Docket Item #'s 10 & 11  
BAR CASE #'s 2008-0040 & 0043

BAR Meeting  
April 16, 2008

**ISSUE:** New construction and waiver of HVAC rooftop screening requirement

**LOCATION:** 1309 King Street

**Figure 1: Proposed Front Elevation**

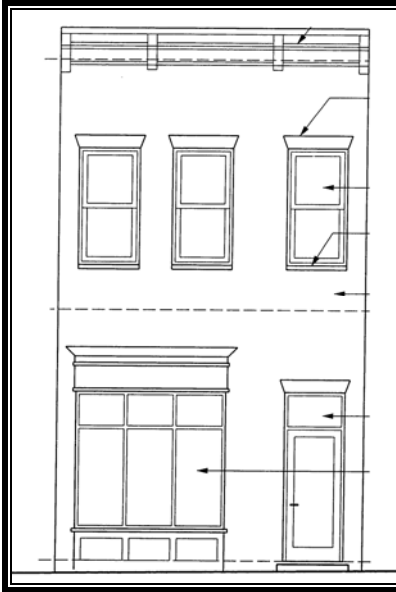
The proposed building is two stories in height and approximately 15' feet in width and 74' in length and will match the front building line along the blockface. The building will have an unpainted brick façade with a tri-partite bay window projecting approximately 20" with painted wood panels below, fypon trimwork and a single light wood door with transom on the first level. The second level will have three evenly spaced one-over-one clad wood double hung windows with brick sills and jack arches. It will be flat roofed with a decorative corbelled brick cornice with four brackets

In the opinion of Staff, the materials, scale and historical details of the proposed new building are appropriate to the historic character of the King Street commercial corridor. The wood bay and transom windows are similar to the historic approach for the display of retail goods for many other building along King Street. The cornice line of the building effectively mediates between that of the three story building to the east and that of the two story building to the west. The overall character of the new building is similar to that approved by the Board for other new commercial buildings along King Street in the last few years such as just to the west at 1303.
